CBD & South-East Light Rail Project - Modification 1 SSI 6042 (MOD 1)

Modification to CBD and South East Light Rail Project

Submitted to NSW Department of Planning and Environment
On Behalf of University of NSW

December 2014 ■ 13533

Figure 4 – Operating Frequency at opening year – Randwick and Kingsford Lines

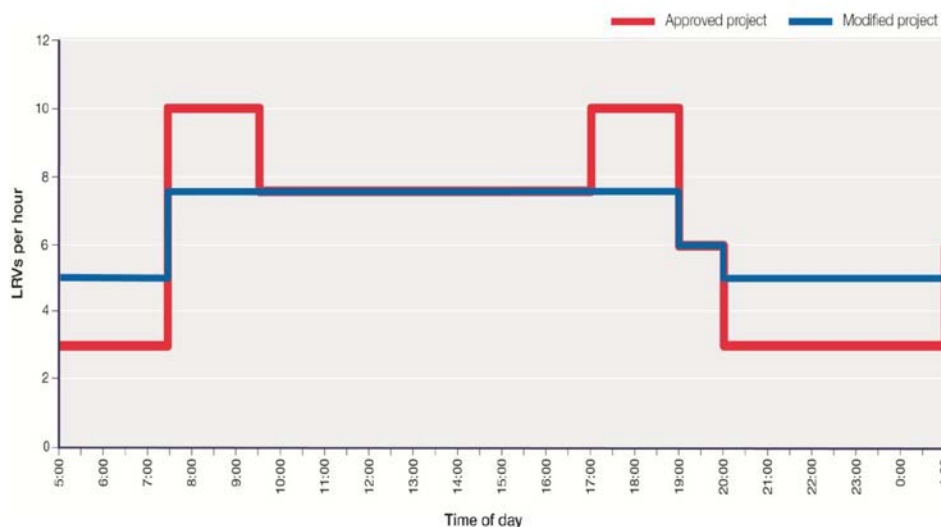
The proposed change in LRV capacity (from 300 to 466) and change in peak hour service frequency (from 10 vehicles per hour to less than 8vph at opening (2021)) (see **Figure 4**) will significantly affect the patronage of the UNSW stops at Anzac Parade and High Street. Importantly, the Modifications Report does not consider the impacts of these changes on the operation of the two stops, particularly with regard to platform capacity, level of service, and pedestrian safety.

Based on the detail provided by TfNSW, it is understood that the Project will commence operations in 2021, while the future service frequencies may not be implemented until 2031, ten years after opening if at all.

Figure 6 – Figure 3.17 of the Modification Report – Affected blocks (identifying New College)
Source: TfNSW + JBA

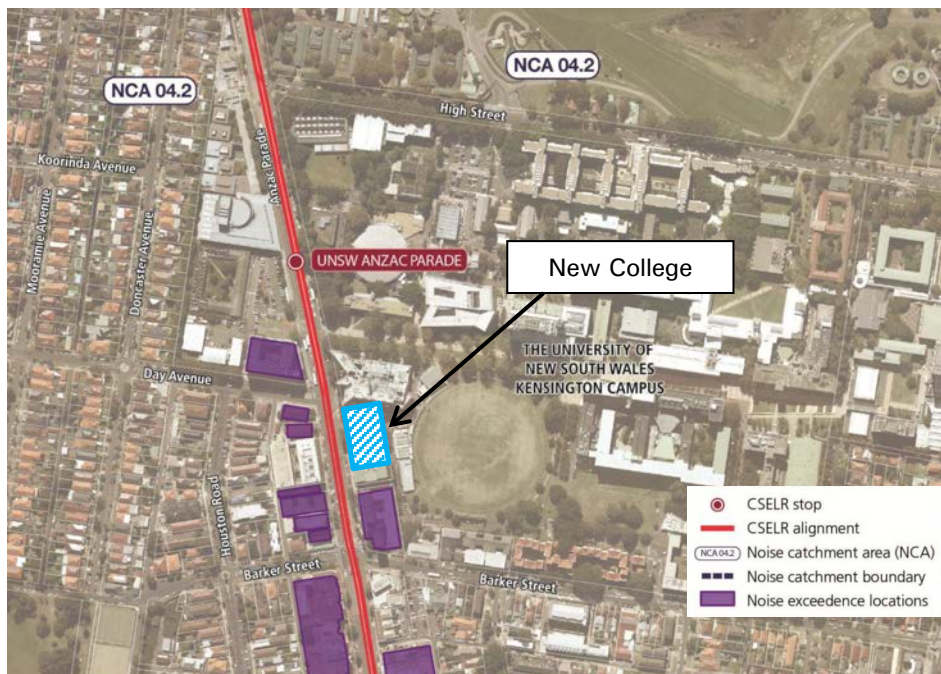
Table 3.4 of the Modifications Report indicates a significant increase in the noise exceedances (above excepted levels) within the NCA04.2 catchment area which includes Kensington and UNSW. The modifications result in an addition 22 'blocks' and 44 individual receptors being affected. However Figure 3.17 of the Modification Report does not identify New College, a UNSW residential college located on the eastern side of Anzac Parade. Figure 3.17 of the Modification Report has been reproduced below (**Figure 6**) with the location of New College shown.

Given the methodology adopted in Table 3.4 of the Modifications Report, concern is also raised that the extent of impact significantly under-represents the potential impact on UNSW's high density residential buildings.

Figure 8 – UNSW High Street Stop – Critical Constraints to be addressed
Source: Tzannes and UNSW

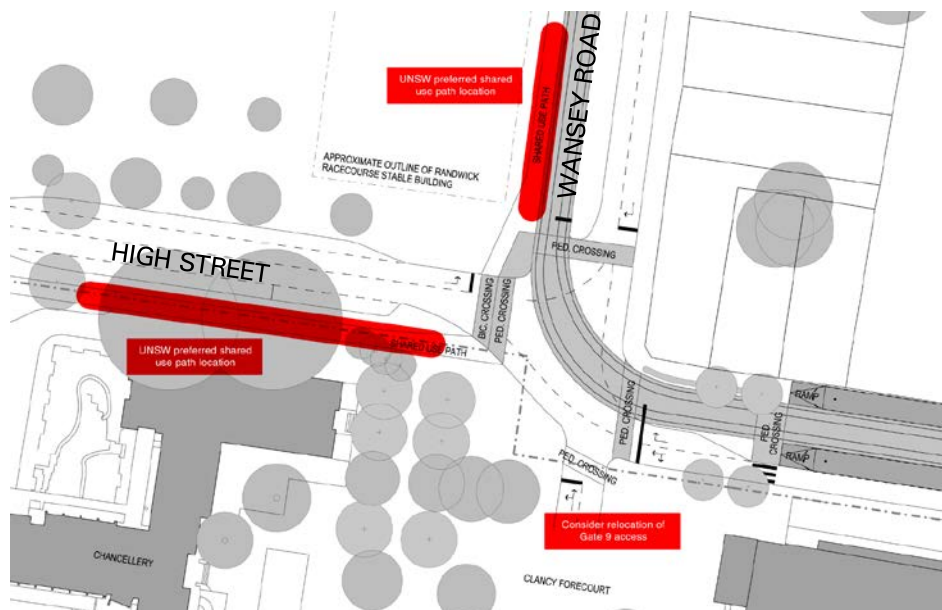
UNSW considers that the safer location for the shared path on Wansey Road is on the 'outside' of the tracks, as shown below in **Figure 8** and provide at **Appendix A**.
